To: Development Permit Panel

File: DP 20-893127

Re: Application by Design Work Group Ltd. for a Development Permit at 11480 and 11500 Railway Avenue

DP 20-893127 – THREE ARTERIAL ROAD DUPLEXES

DP 20-893127 PLAN # 2

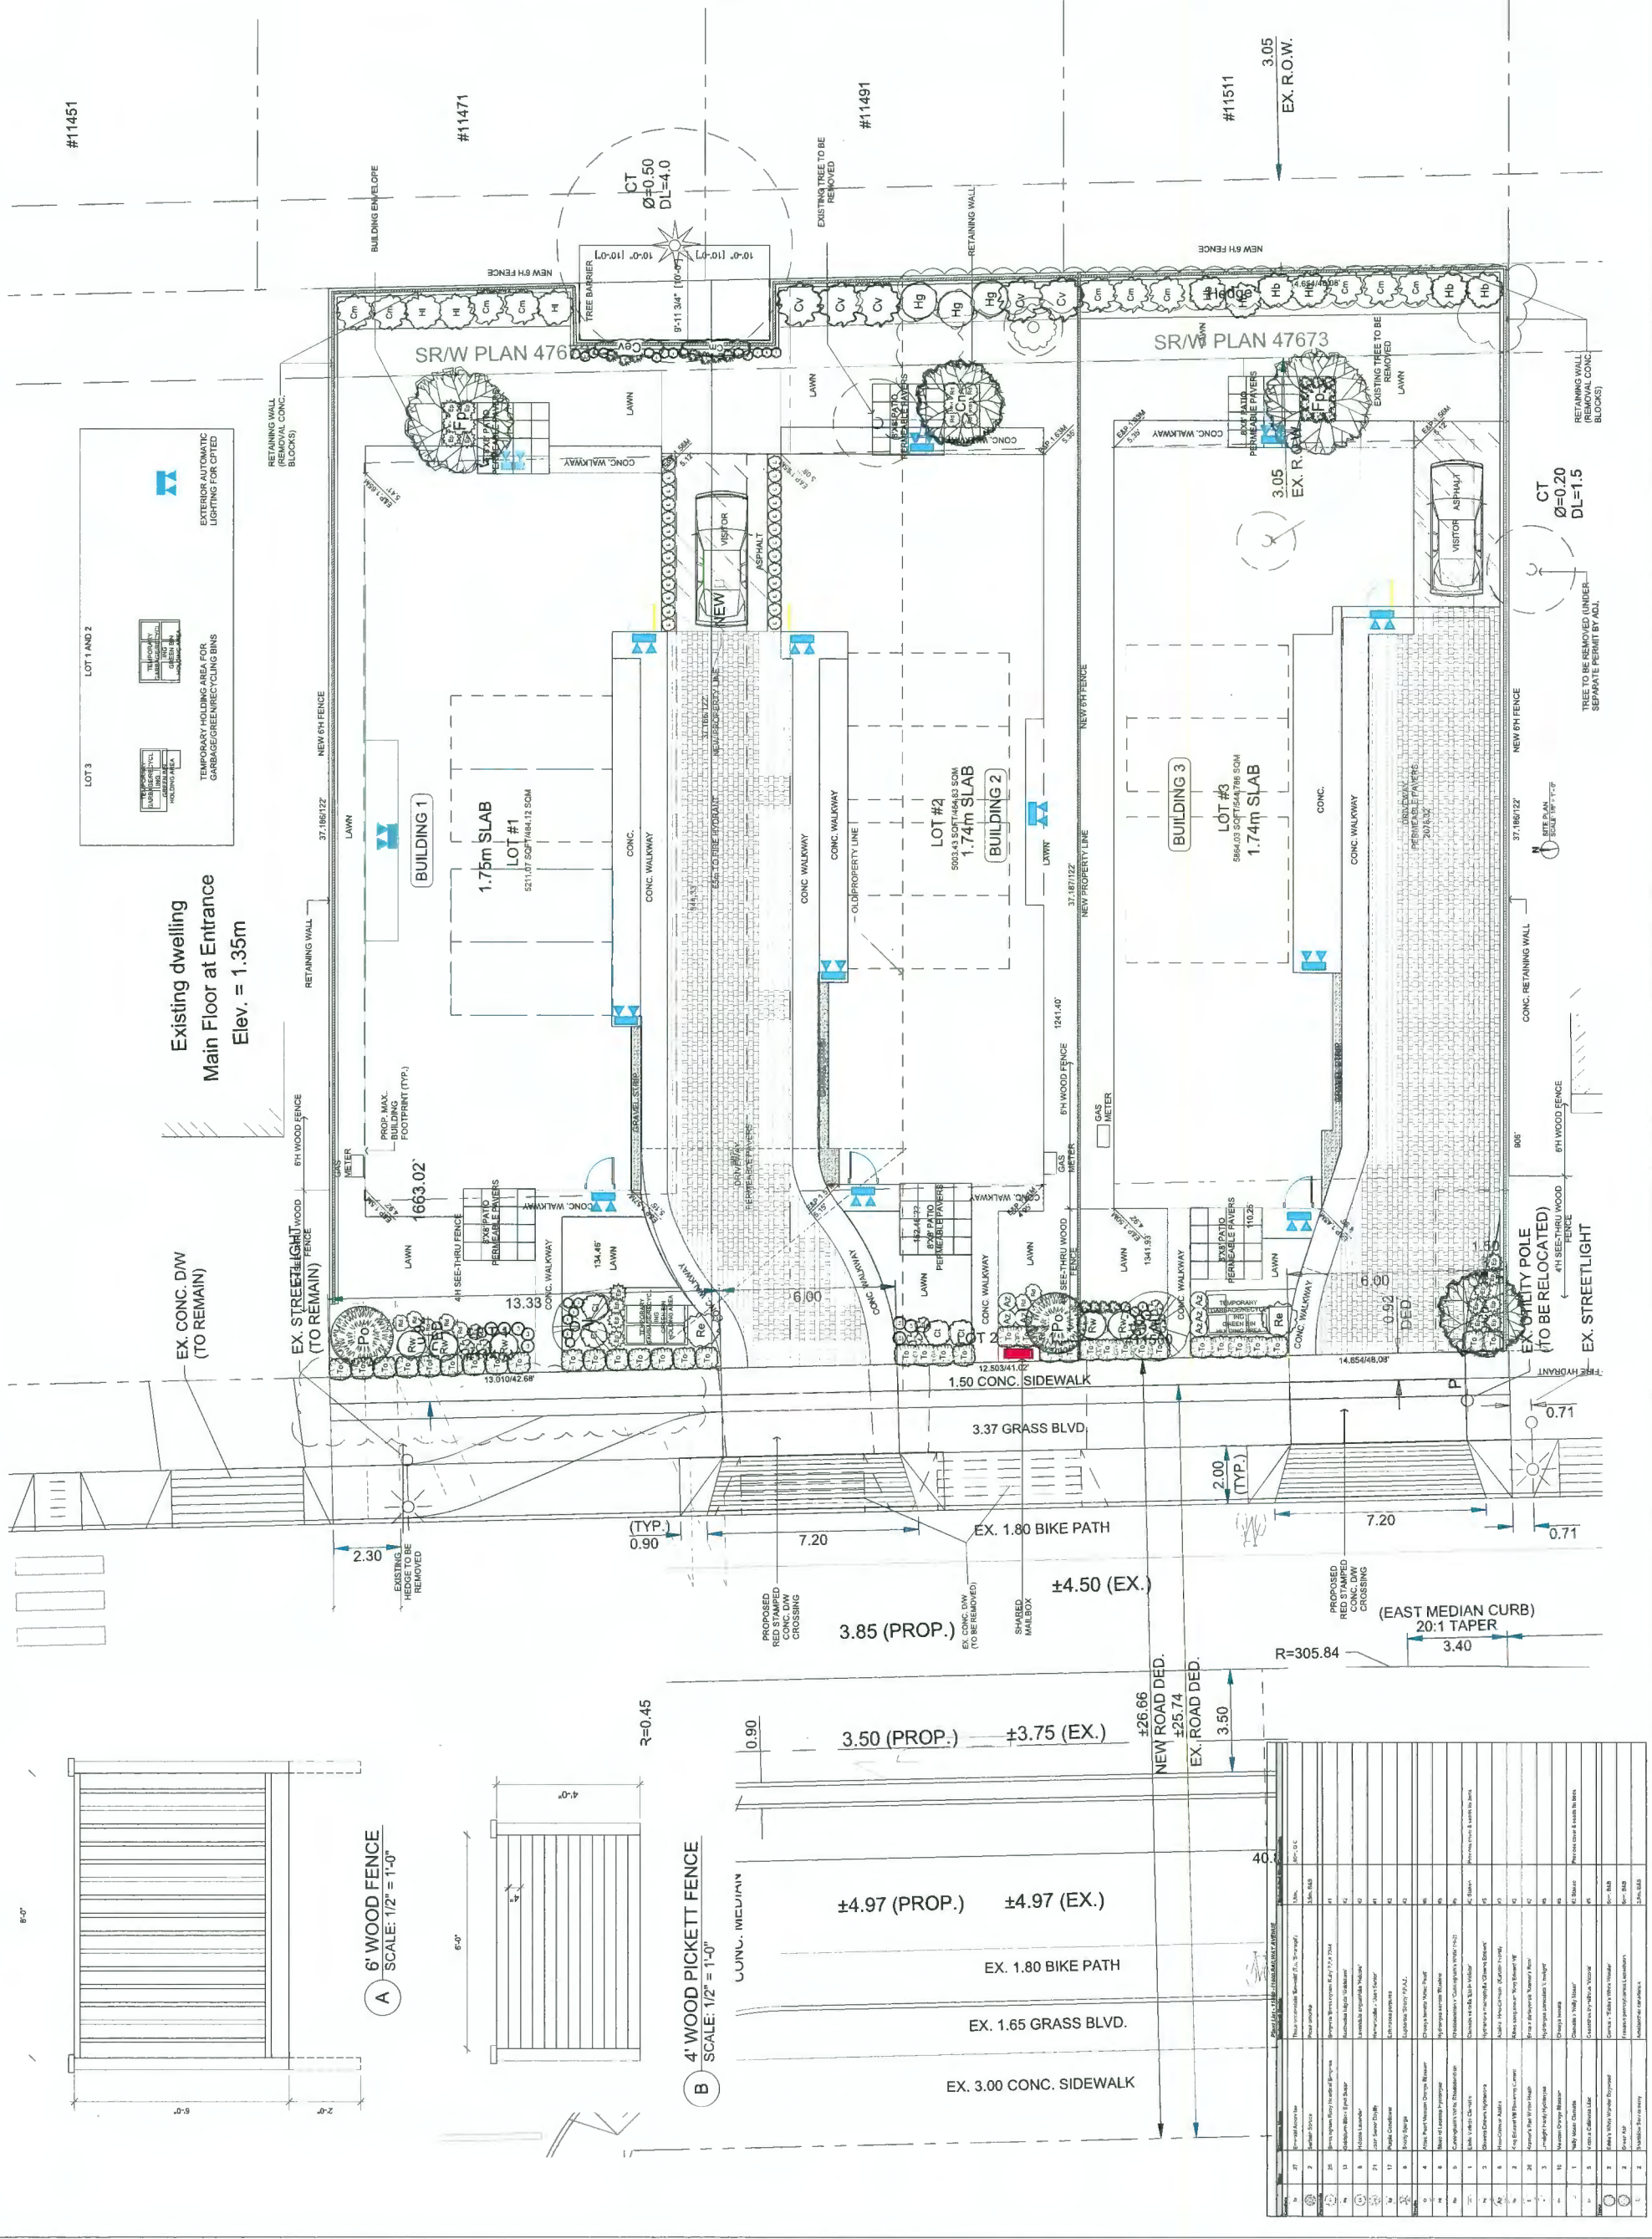
- One off-site tree on a neighbouring property to the east will be retained. Tree protection fencing is required prior to demolition of the existing buildings, and arborist supervision is required for any works within the tree protection zone. This tree and the required fencing are shown on Plan # 2.
